Palo Verde Nuclear
Generating Station

Subject: Palo Verde Nuclear Generating Station (PVNGS)
Units 1, 2, and 3
Response to NRC Questions, September 14, 1998
Pre-decisional Enforcement Conference

**Response to NRC Questions,
September 14, 1998 Pre-decisional
Enforcement Conference**

Attachment 1
HPSI Unavailability Graph

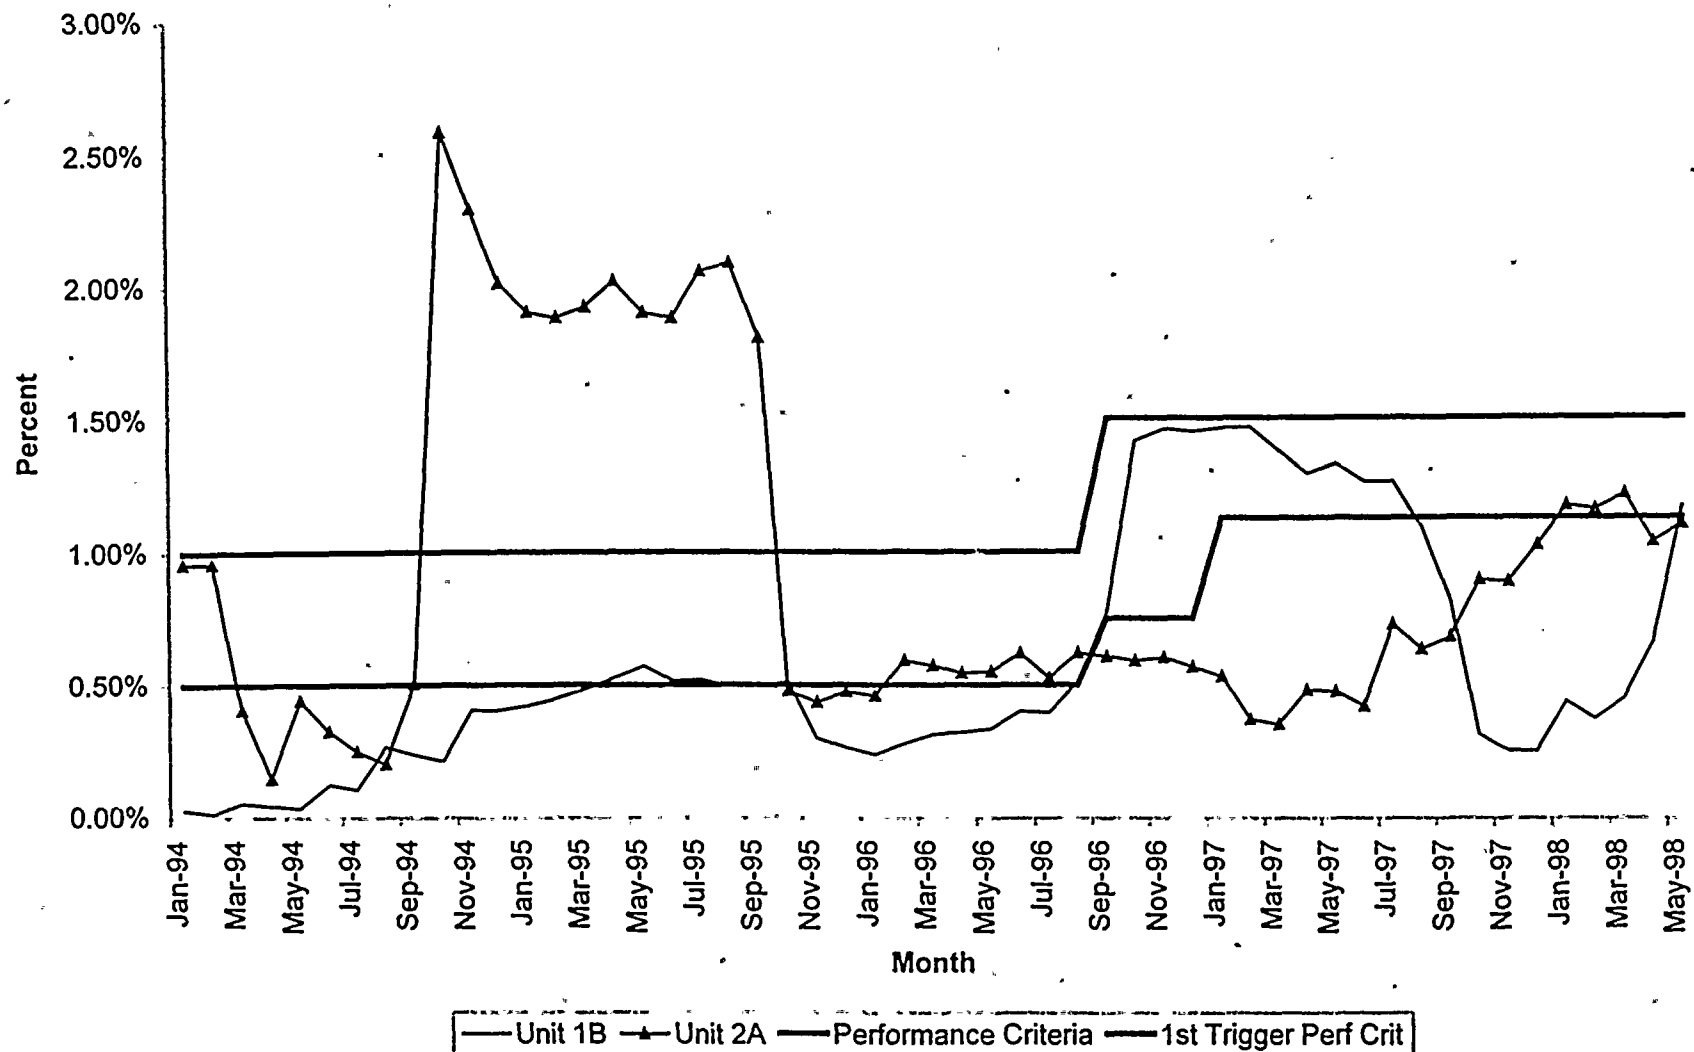
5.A) Provide an explanation of how the HPSI Check Valve as-found conditions were factored into the Maintenance Rule decisions.

U1, U2, and U3 HPSI systems were put into a(1) on August 18, 1998, in Expert Panel Meeting #170 due to a repetitive functional failure identified on HPSI check valve (1PSIAV 0404) after performing corrective maintenance. On September 24, the HPSI system unavailability was reviewed during Maintenance Rule Expert Panel Meeting # 174. The Expert Panel adopted the position that the HPSI check valve failure would impact unavailability on the redundant HPSI train when the HPSI pump on the same train as the failed check valve was taken out of service and was unable to start. The reverse flow could only exist if two conditions existed simultaneously. First, the check valve had to be failed. Second, the HPSI pump on the same train as the failed check valve was unavailable. If both pumps were available, the back flow would not occur. See Attachment 1.

The following unavailability times have been added to the redundant HPSI trains, after reviewing clearances, Electrical/Mechanical/I & C work, and outages that affect the HPSI pump availability.

Failure of 1PSIAV404 has added the additional unavailability time of 45.45 hours to Unit 1 HPSI Train B.

Failure of 2PSIBV405 has added the additional unavailability time of 64.48 hours to Unit 2 HPSI Train A.
